State of Alaska
Department of Fish and Game
Division of Sport Fish

Nomination Form
Anadromous Waters Catalog

Anadromous Waters Catalog Number of Waterway: 252-30 ~~252-34-10005~~ -2001 10050

Name of Waterway: unnamed tributary Valley Creek

Figure 1

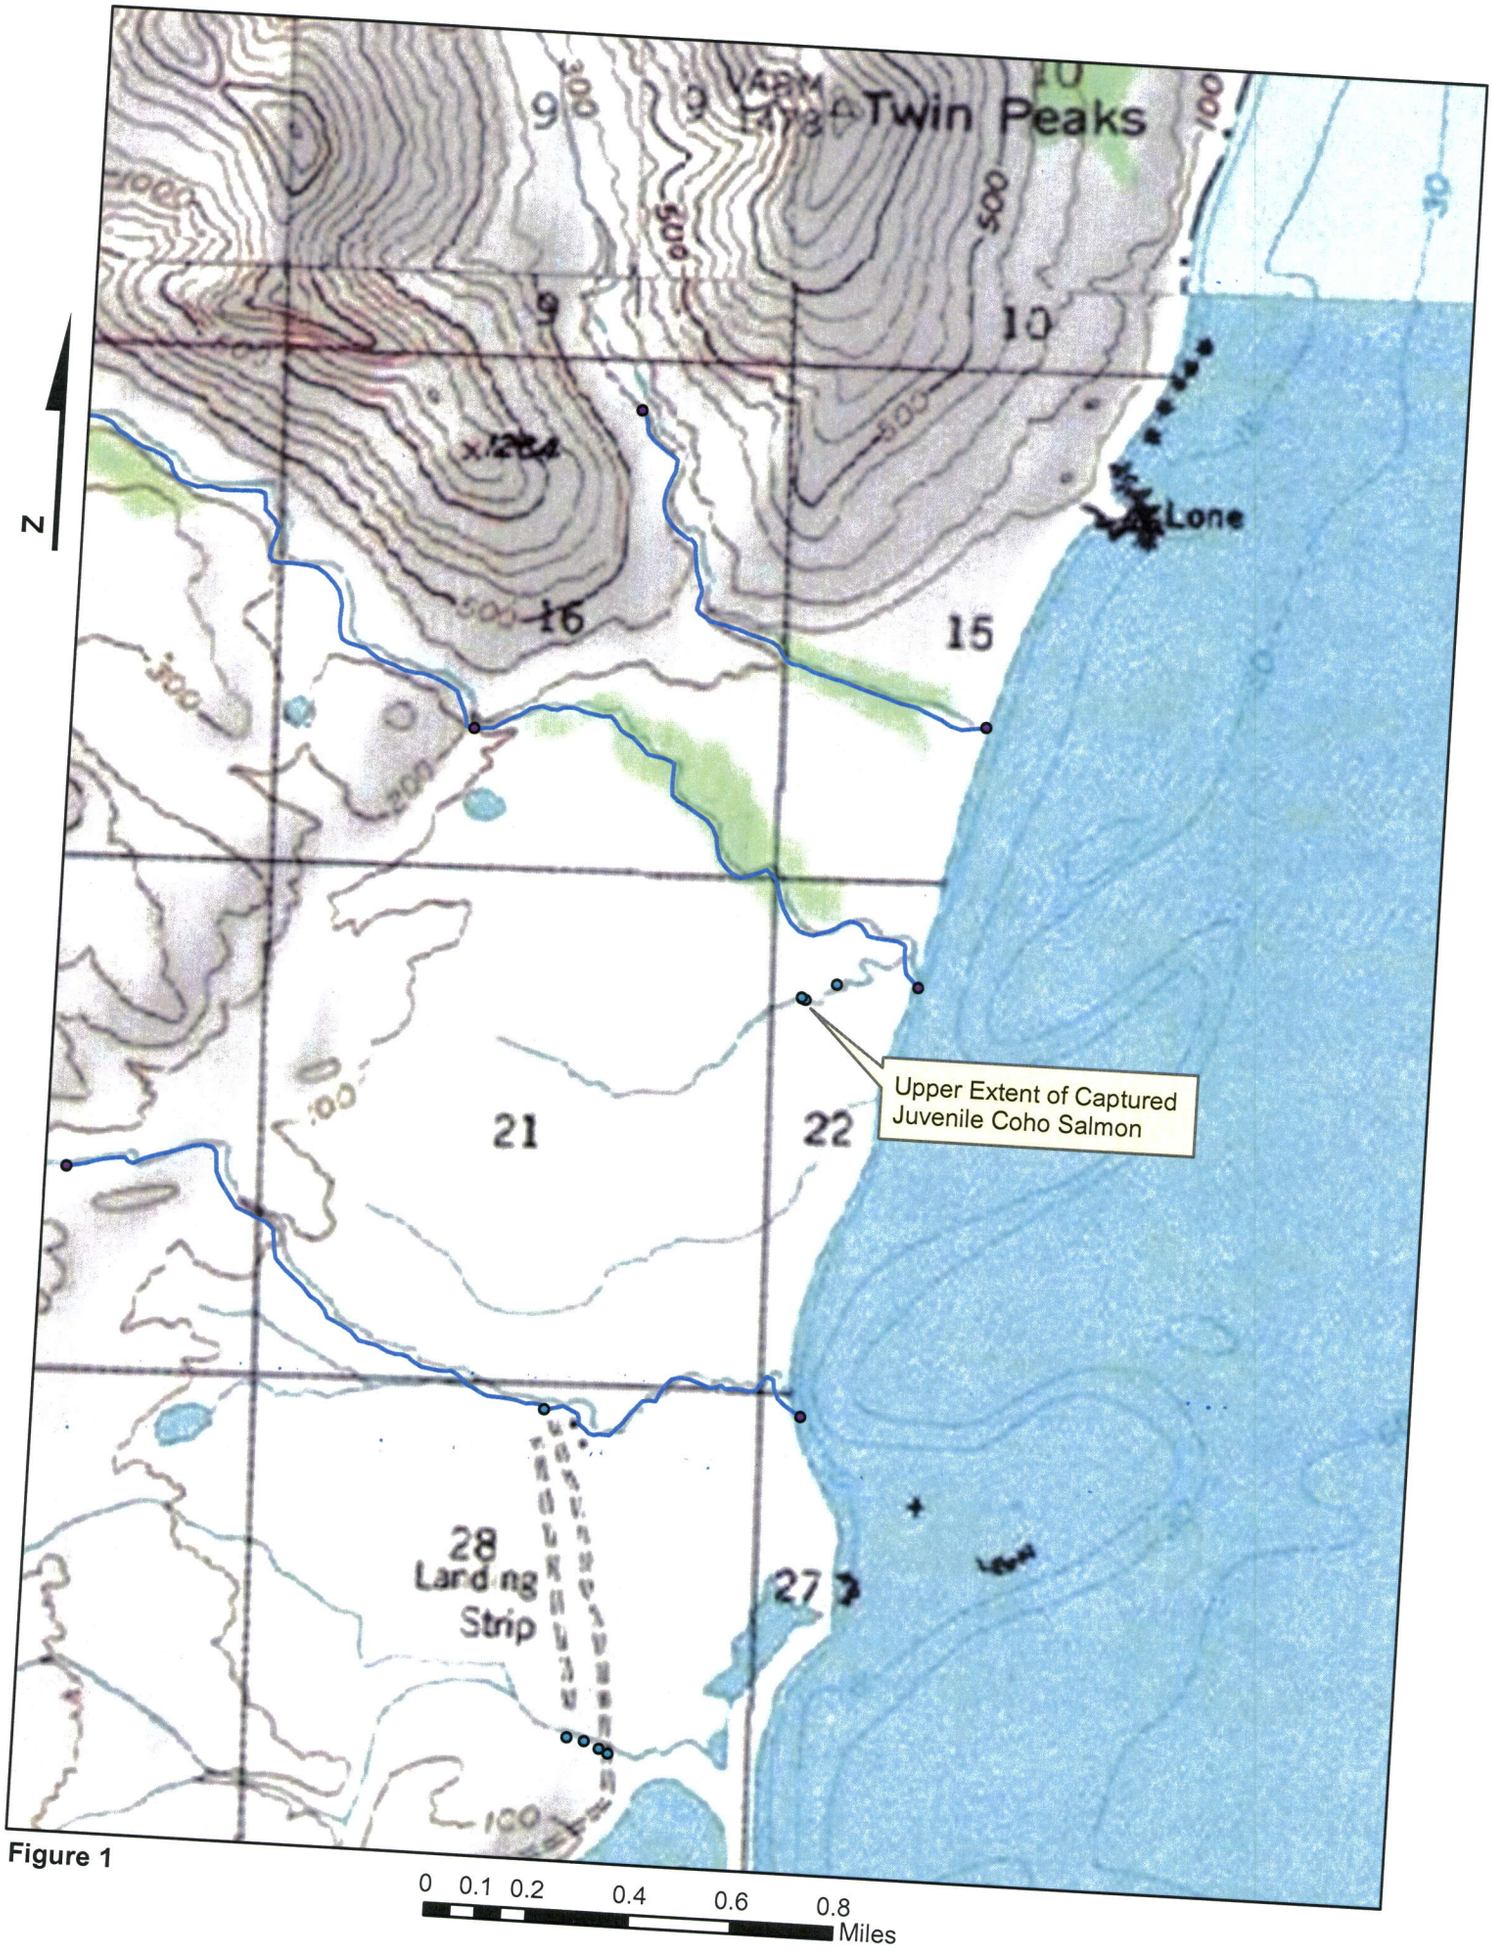
During a culvert survey I used an electroshocker to sample an unnamed tributary to Valley Creek (Figures 1 and 2). I captured and released two juvenile coho salmon at Lat 58.169255, Long -152.738251, and four juvenile Dolly Varden. Valley Creek is about 17 feet wide and less than 2% slope. The riparian habitat is damaged by cattle grazing and foot traffic.

Update hydrography and move mouth pt for 252-34-1005 10050
Add new stream w/coho salmon Rearing 252-34-10005-2001 10050

COR
COR
Addnew Strem 259.30 - 10050
~~252-34 10005~~ 2001
w/coho Salmon
Rearing

Revise hydrography for
~~252-34 10005~~ using
259-30 10050 BDL
move
mouth pt
as well.
